World Forum for Harmonization of Vehicle Regulations**Working Party on Automated/Autonomous and Connected Vehicles*****Fifth session**

UN Regulation No. 79:**Automatically Commanded Steering Function****Proposal for a Supplement to the 03 series of amendments to
UN Regulation No. 79 (Steering equipment)****Submitted by the expert from the European Association for
Electromobility****

The text reproduced below was prepared by the expert from the European Association for Electromobility (AVERE) introducing an amendment to UN Regulation No. 79. It is aimed at clarifying the text of the Regulation. It is based on ECE/TRANS/WP.29/GRVA/2019/26. The modifications to the existing text of the Regulation are marked in bold for new and strikethrough for deleted characters.

Picture 1
Analysis of max lateral acceleration occurrence and related vehicle speed distribution,
based on a globally distributed set of 16.500 Tesla vehicles

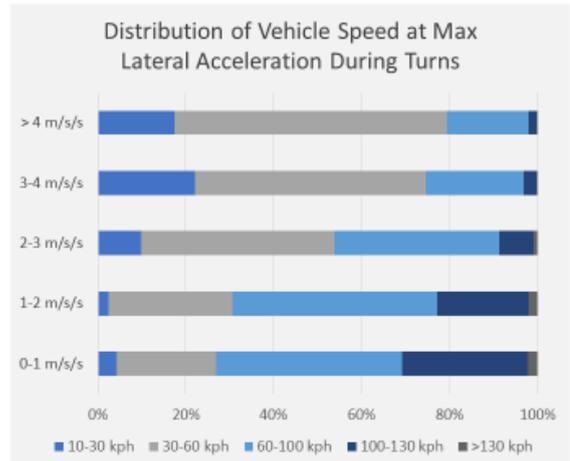
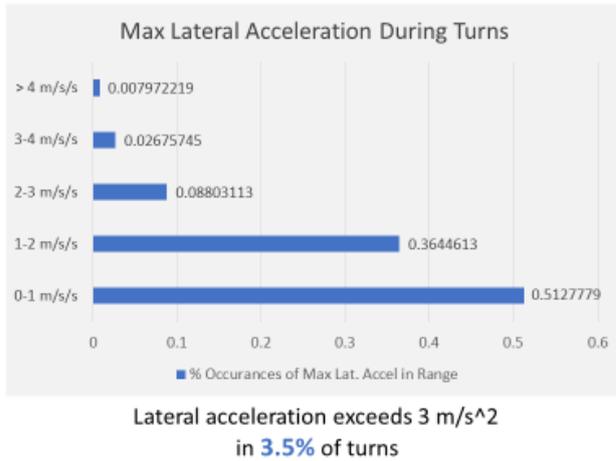
2. Analysis based on manual driving of a globally distributed set 16.500 vehicles, assessed over the course of 28 days spread over 4 months shows that lateral acceleration values exceed 3m/s^2 in 3,5% of the turns. A significant majority of lateral acceleration cases above 3m/s^2 occur at speeds up to 100 km/h as shown on the distribution graph below. (Picture 1 below) For Europe, a similar analysis of 1.250 Model 3s shows lateral acceleration values of 3m/s^2 being exceeded in 4,8% of the turns, with again a significant majority of the cases above 3m/s^2 occurring at speeds up to 100 km/h. (Picture 2 below)

Picture 3
Analysis of the maximum lateral acceleration encountered in curves on a per trip basis. Data presented of 16.500 globally distributed Tesla vehicles (left) and 1.250 EU Model 3s (right)

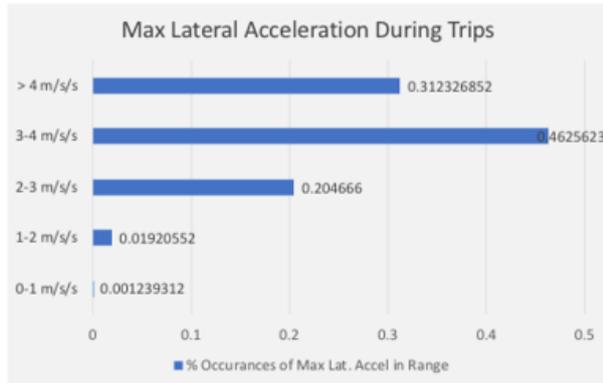
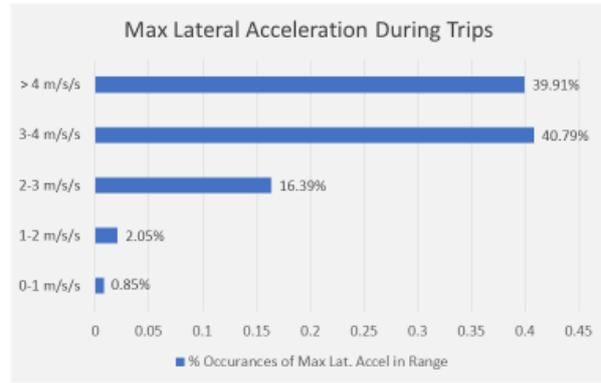
3. The low count of turns however provides a misleading conclusion of the regularity of customers encountering curves with higher lateral acceleration incidents. If we assess how frequently a driver encounters lateral acceleration values above 3m/s^2 on a per trip basis, analysis of a global set of 16.500 vehicles indicates this limit being breached at least once in 76,1% of all trips that take place. A trip is defined as a vehicle leaving from a parked position until it parks again. A similar analysis of 1.250 Model 3s in Europe indicate the lateral acceleration limit of 3m/s^2 being breached at least once in 80.7% of all trips. (Picture 3 below) This implies that a driver can consistently encounter a curve where lane-keeping behavior will be limited on a daily basis.
